# Access Compliance Report

## Public Rights-of-Way

### (Curb Ramps)

Intersection ID: 53925	Main Street: RORY_GLEN_LN	Cross Street: PINYON_PINE_LN	Location: SW
ADA ID: ED9369C7A509	Ramp Type: BlendTrans1	Initial Pass/Fail: Fail	Overall Compliance: No
			Severity Score: 18.75

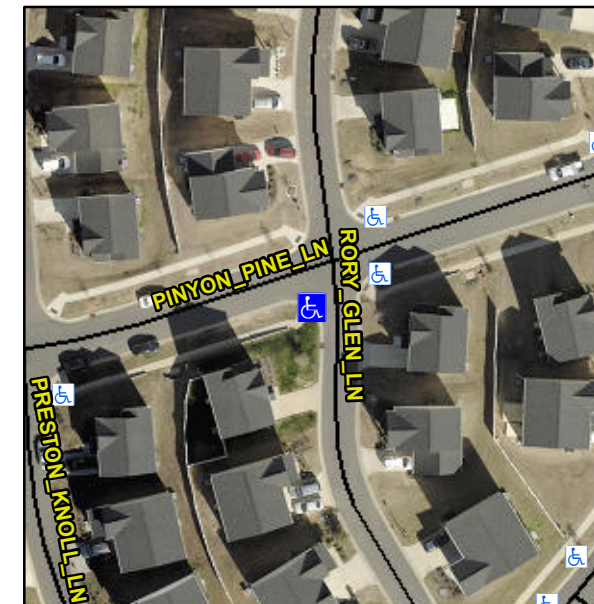
**NO LT SW**

**Not Found, R304.5.1, R304.5.3**

Compliance	Description	Data	Compliance	Description	Data
N/A	Ramp Length (in)	98.5	Yes	BlendTrans Slope (%)	0.4
No	Ramp Width (in)	32.5	No	BlendTrans XSlope (%)	4.0
N/A	Flare Type LT	N/A	N/A	Flare Type RT	N/A
N/A	Flare Slope LT (%)	N/A	N/A	Flare Slope RT (%)	N/A
N/A	Flare Traversable LT?	N/A	N/A	Flare Traversable RT?	N/A
N/A	Landing Length (in)	N/A	N/A	DWS Provided?	N/A
N/A	Landing Width (in)	N/A	N/A	DWS Contrast?	N/A
N/A	Landing Slope (%)	N/A	N/A	DWS Length (in)	N/A
N/A	Landing X Slope (%)	N/A	N/A	DWS Full Width?	N/A
N/A	Landing Curb? (Y/N)	N/A	N/A	DWS Offset (in)	N/A
N/A	Shared Landing?	N/A			
N/A	Gutter Ponding?	N/A	N/A	Gutter Slope (%)	N/A
N/A	Gutter Lip Ht (in)	N/A	N/A	Gutter X Slope (%)	N/A
N/A	Painted X Walk1?	No	N/A	Painted X Walk2?	No
	X Walk 1 Direction	To E		X Walk 2 Direction	To N
	X Walk 1 Width (in)	N/A		X Walk 2 Width (in)	N/A
	X Walk 1 Slope (%)	7.2		X Walk 2 Slope (%)	1.9
	X Walk 1 X Slope (%)	3.9		X Walk 2 X Slope (%)	5.6

N/A	Ramp inside XWalk1?	N/A	N/A	Ramp inside XWalk2?	N/A
	Road Slope (%)	6.3		Clear Space?	N/A
	Road X Slope (%)	4.5	N/A	Clear Space to XWalk (in)	N/A
N/A	Any Obstructions?	N/A	N/A	Storm Grate/Utility Hazard?	N/A
	Obstruction Type			Storm Grate/Utility Type	
		N/A			N/A
			Yes	Surface Condition? (G/P)	Good
			No	Curb Slope (%)	12.1

**Remove & Replace Curb Ramp With Two New Directional Ramps or Equivalent.**
